Subject Response to U S EPA Comment Letter Supplemental Data Collection &  
Evaluation Report McGraw Edison Superfund Site Centerville Iowa

SUPPLEMENTAL DATA COLLECTION AND EVALUATION  
OF ALTERNATIVE GROUNDWATER REMEDY  
(IRON REACTIVE PERMEABLE BARRIER  
AND NATURAL ATTENUATION)

McGRAW-EDISON SUPERFUND SITE  
CENTERVILLE, IOWA

**RE RESPONSE TO EPA COMMENTS ON REPORT ON SUPPLEMENTAL DATA  
COLLECTION AND EVALUATION OF ALTERNATIVE GROUNDWATER REMEDY  
(IRON REACTIVE PERMEABLE BARRIER AND NATURAL ATTENUATION)  
McGRAW EDISON SUPERFUND SITE  
CENTERVILLE, IOWA  
UAO No VII 94 F0008**

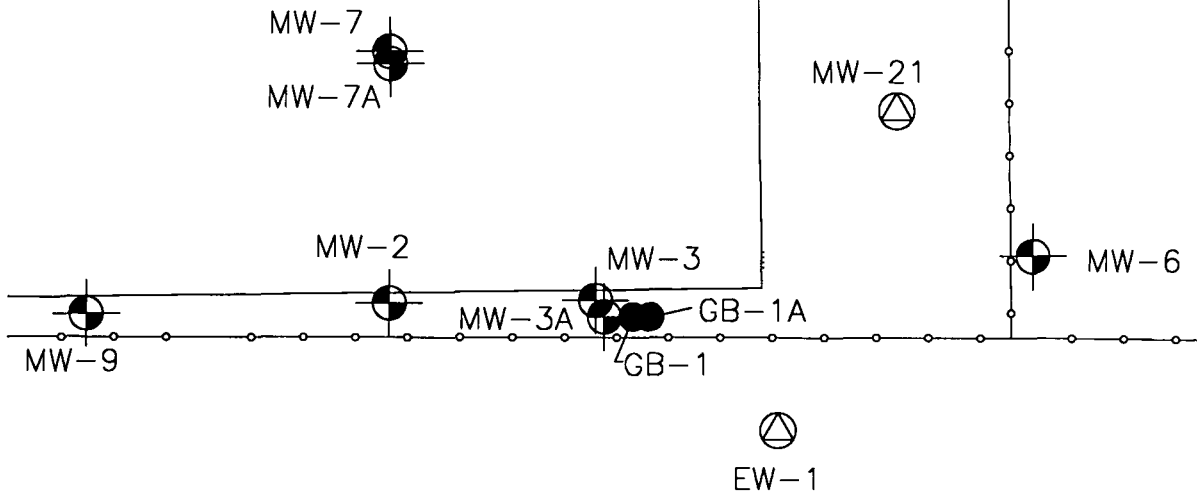
- 7 Page 29, Section 4 1 *The TCE concentration of 1 100 000 ug/L identified in MW 2 should be included on Figure 7*

- 8 Page 30, Section 4 3 *The second paragraph indicates that the majority of the low Eh values are located in the TCE plume as shown in Figure 7 However the majority of the low Eh values actually appear to be located outside the 10 microgram per liter contour line This statement should be revised accordingly*

The TCE concentration of 1 100 000 ug/L identified in MW 2 will be included on Figure 7 of the Revised Supplemental Data Collection Report

The Eh values have been shown as contours on a new Figure and Section 4 3 has been edited in the Revised Supplemental Data Collection Report to reflect the actual data collected in the field

<b>GOLDER SIERRA</b> Atlanta Georgia	TITLE				Leak Off Test Profile	
	CLIENT/PROJECT	DRAWN	BSL	DATE	JOB NO	986 1083
McGRAW EDISON SITE CENTERVILLE IOWA	CHECKED	<i>f j</i>	SCALE	N/A	PAGE NO	11
	REVIEWED	<i>[Signature]</i>	FILE NO	1083 dd2 cdr	SUBTITLE	FIGURE NO
						10

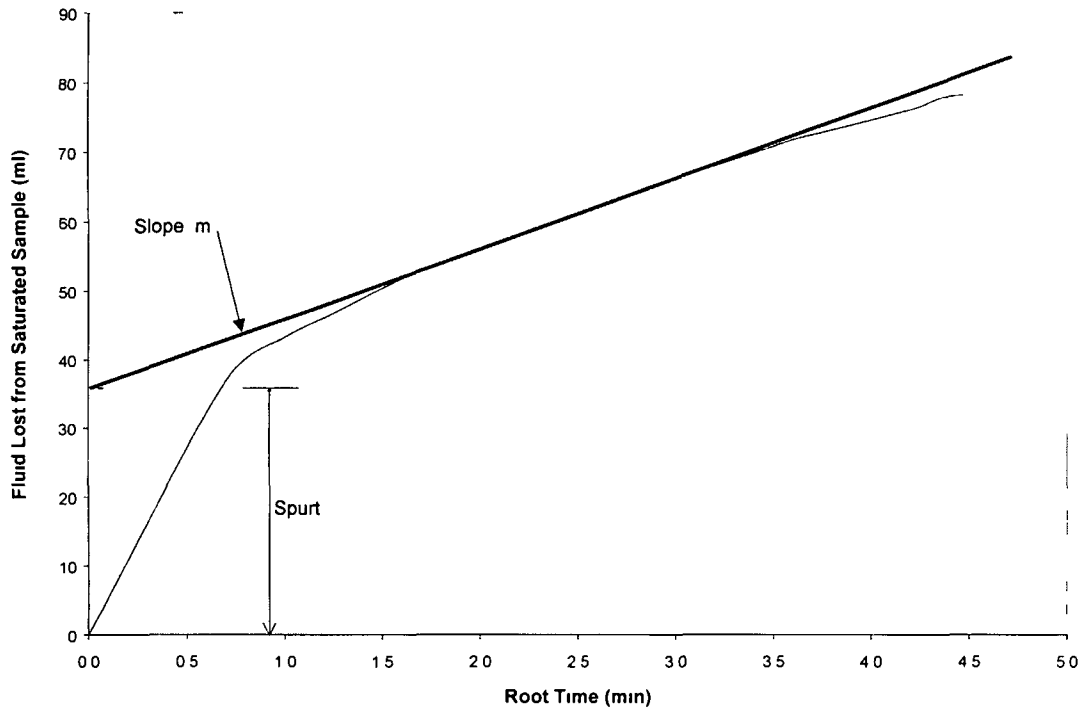
- 4 Page 20, Section 3 3 2 *The first line of the second paragraph refers to Figure 5 The reference should be to Figure 10*

The figure number has been changed in the Revised Supplemental Data Collection Report

<b>GOLDER SIERRA</b>	Atlanta Georgia		TITLE Soil Desorption Test Apparatus				
	CLIENT/PROJECT MCGRAW EDISON SITE CENTERVILLE IOWA		DRAWN BSL	DATE 7/10/98	JOB NO 986-1083	CHECKED <i>[Signature]</i>	SCALE N/A
		REVIEWED <i>[Signature]</i>	FILE NO 1083 dd4 cdr	SUBTITLE	FIGURE NO 17

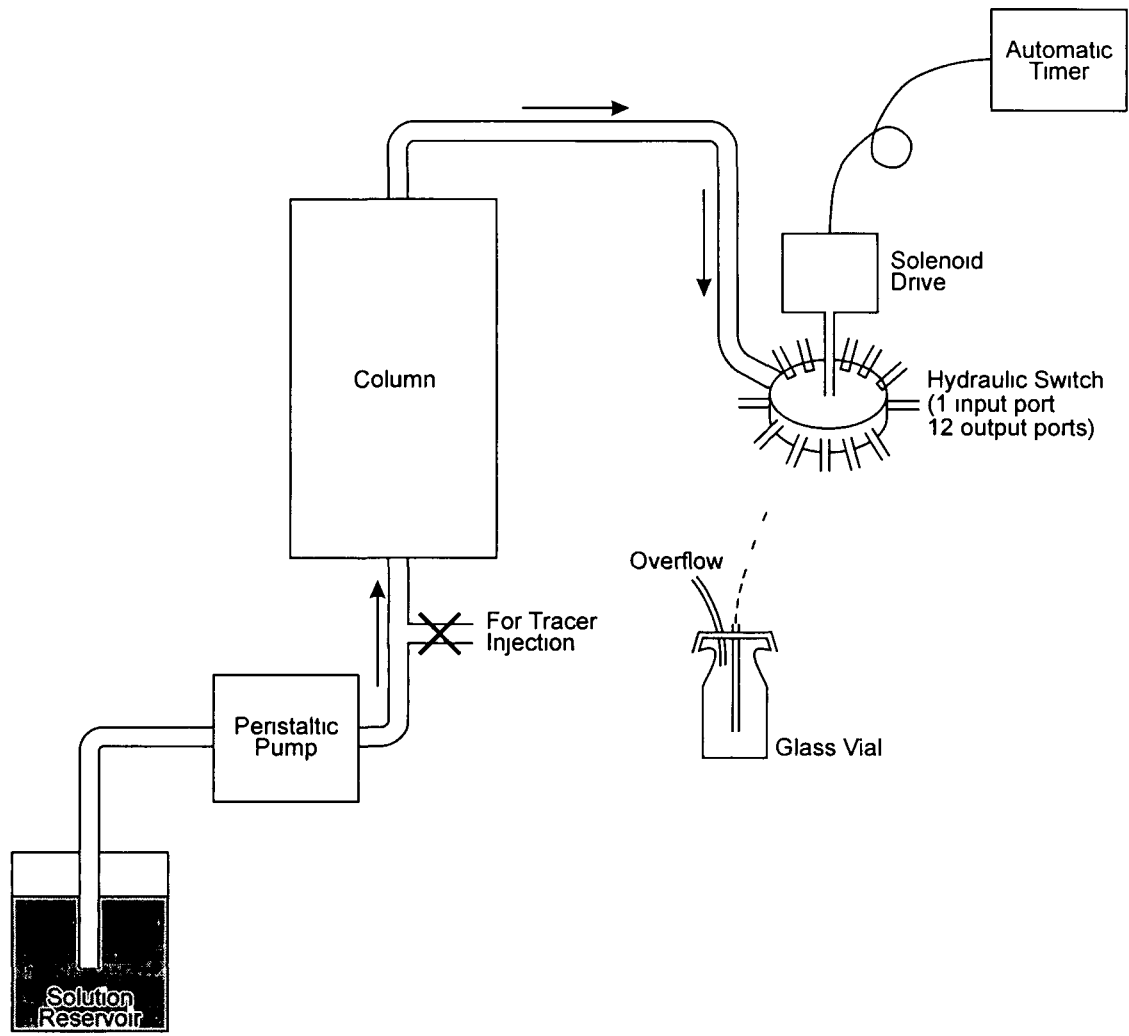
- 6 Page 27, Section 3 6 2 *The reference to Figure 12 in the second paragraph should be to Figure 17*

The figure number has been changed in the Revised Supplemental Data Collection Report

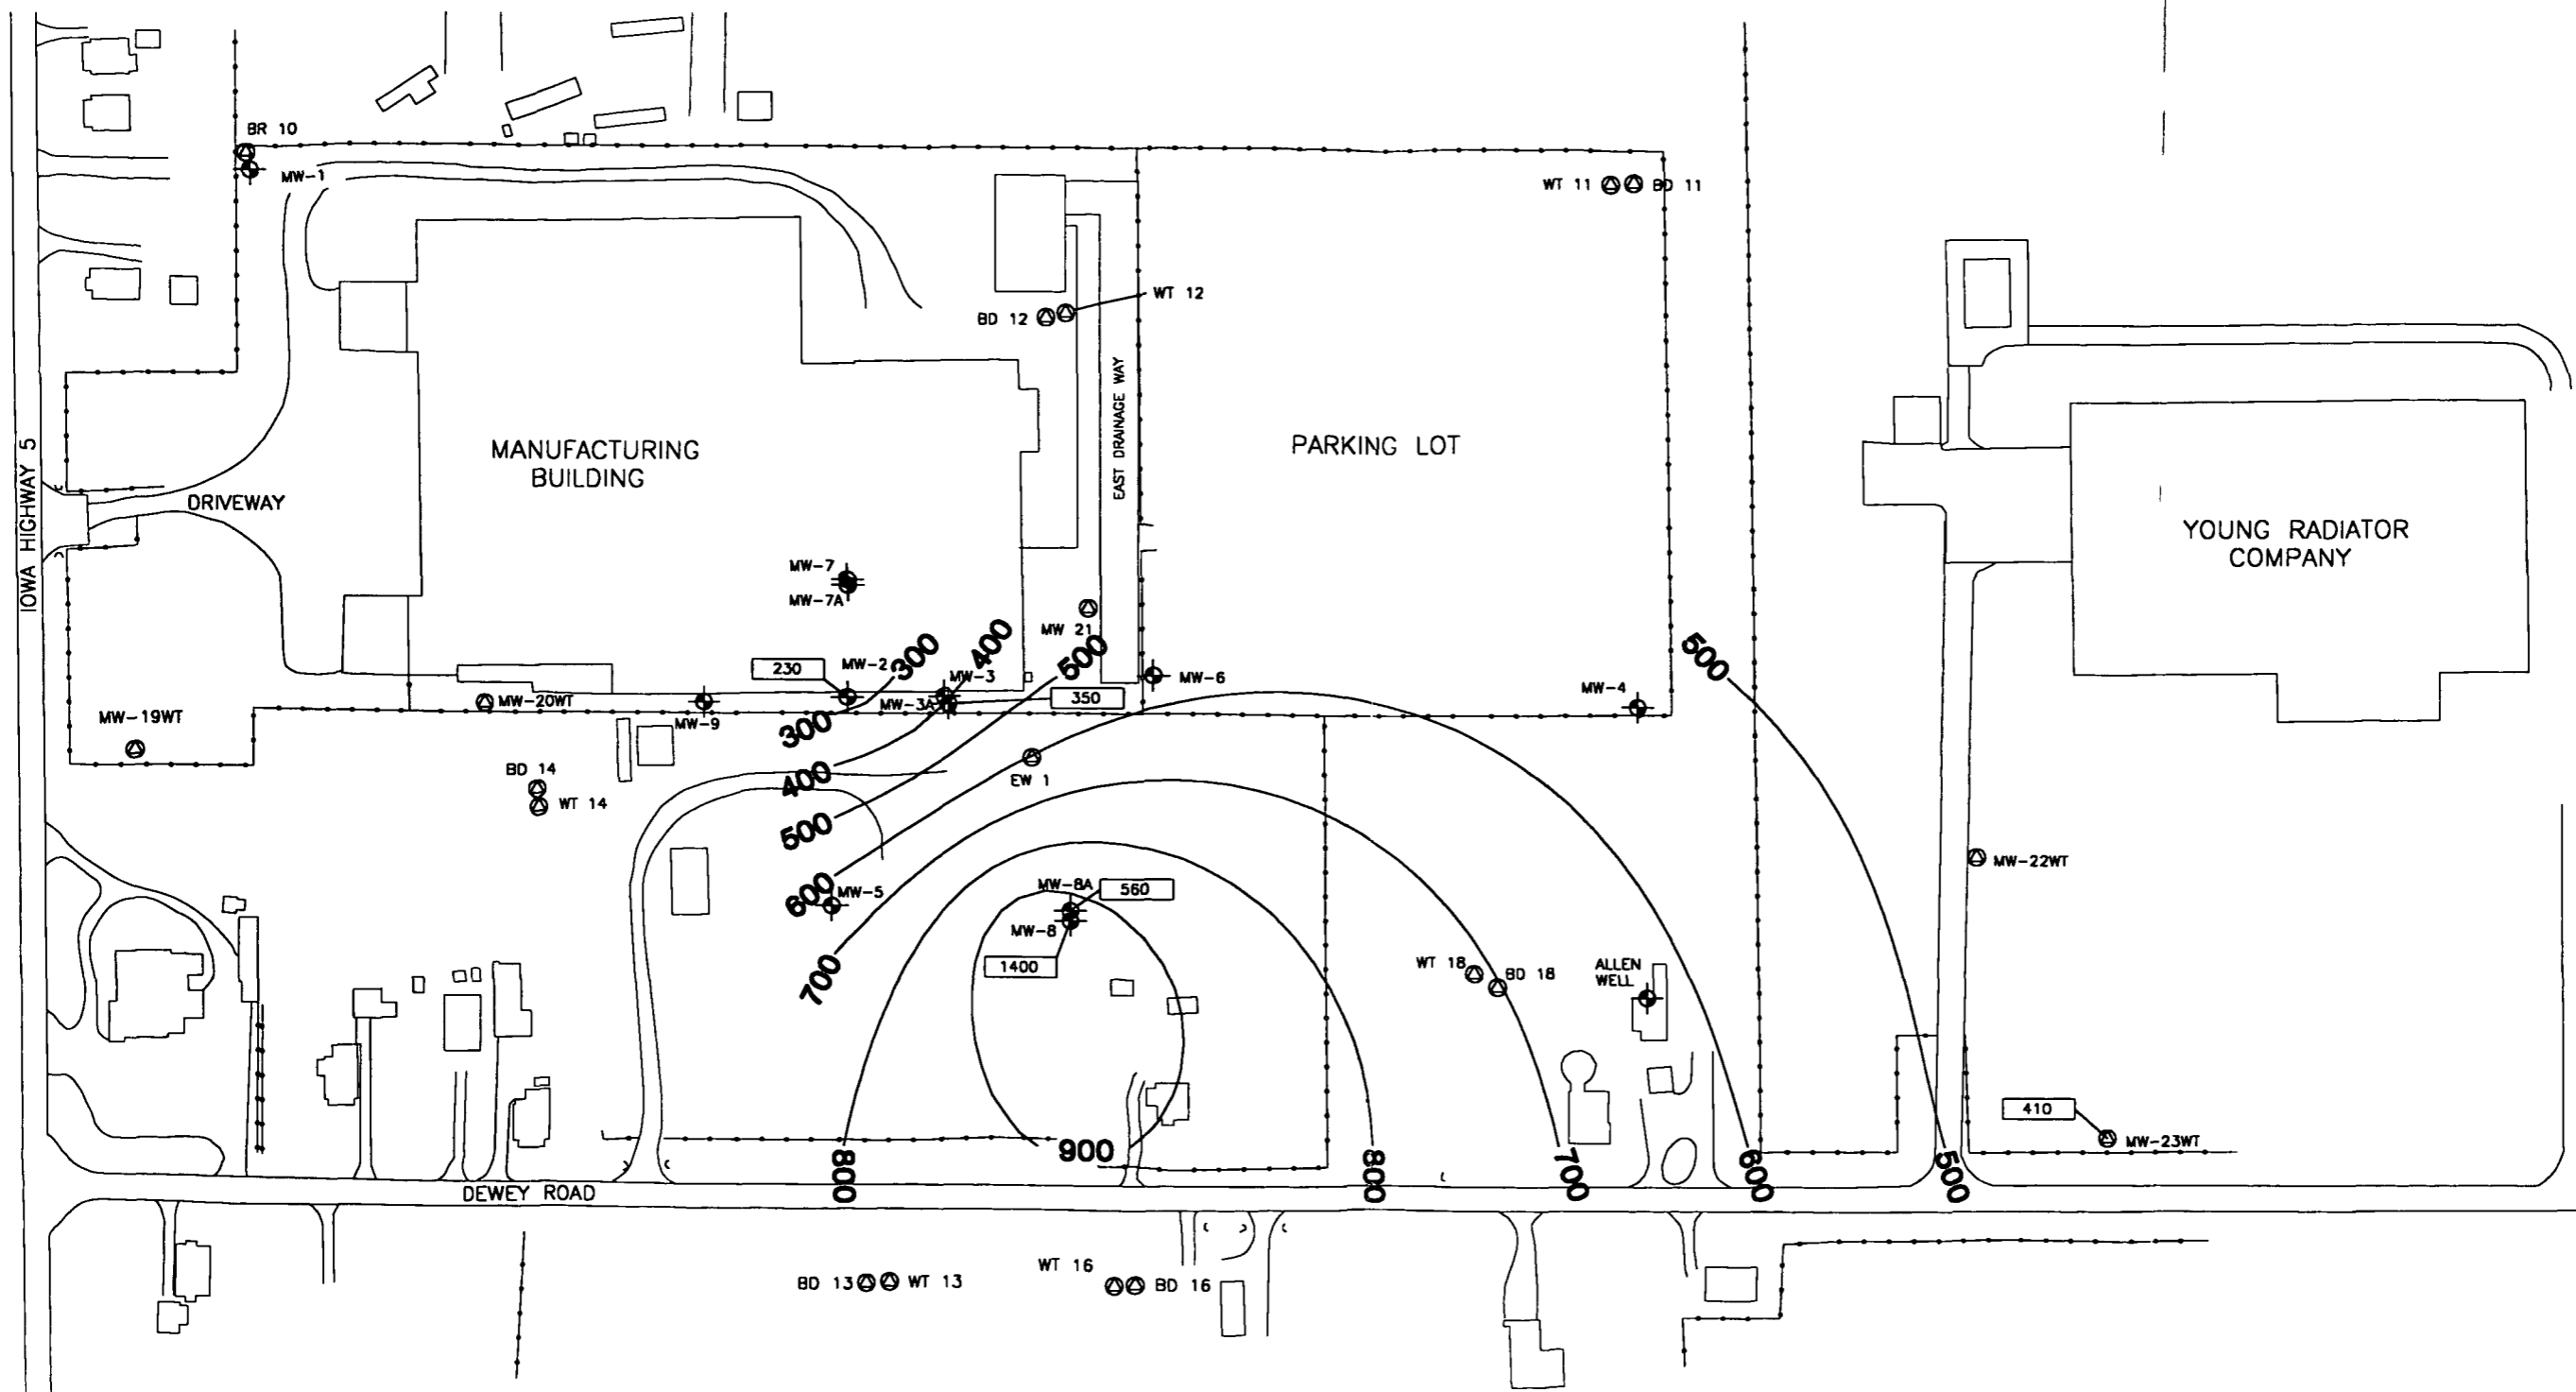
*Please provide additional discussion regarding Figure 23. Discuss the simulations which support the data on this figure. Was the simulation steady state or transient?*
